SAFETY RECALL

TITLE: Addition of a lift door telltale

PRODUCT: MBII MPV 2010 et 2011

Reference : 11-043-LDU

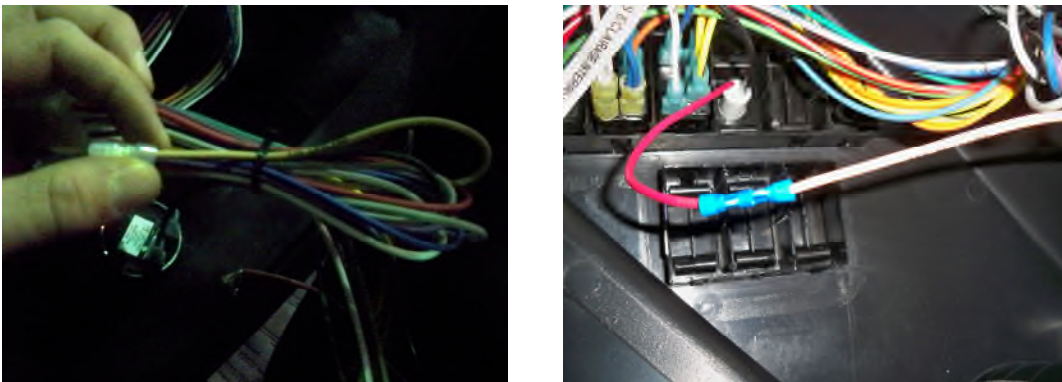
- 1- Remove 3 screws holding the top switch console to access wires. Note: on Ford vehicles, the 5 plastic screws need to be cut and removed and new ones will need to be reinstalled. (supplied)
- 2- Remove the plastic cover plate and install the new cap holding the light.

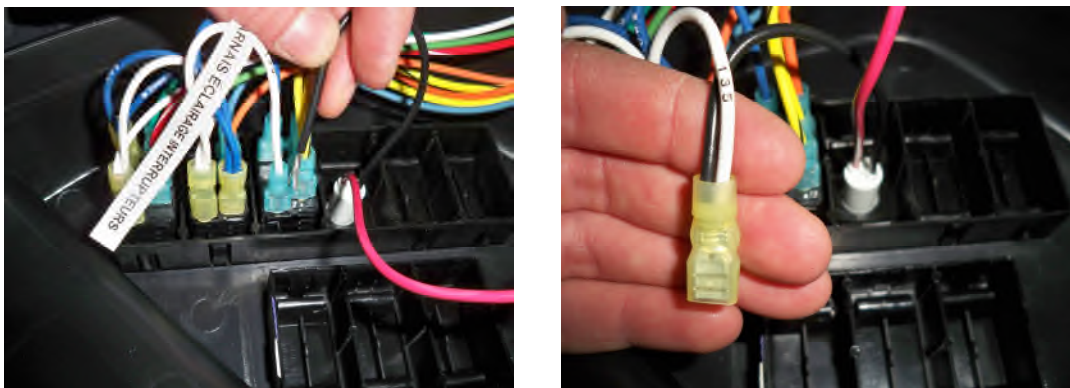
- 3- Locate the unused tan wire # 124 under the console, cut off the closed end connector and use a blue terminal junction to connect it to the light's red wire.

- 4- Connect the alarm's black wire with the white wire of the closest switch with the yellow female connector and reinsert in switch tab.
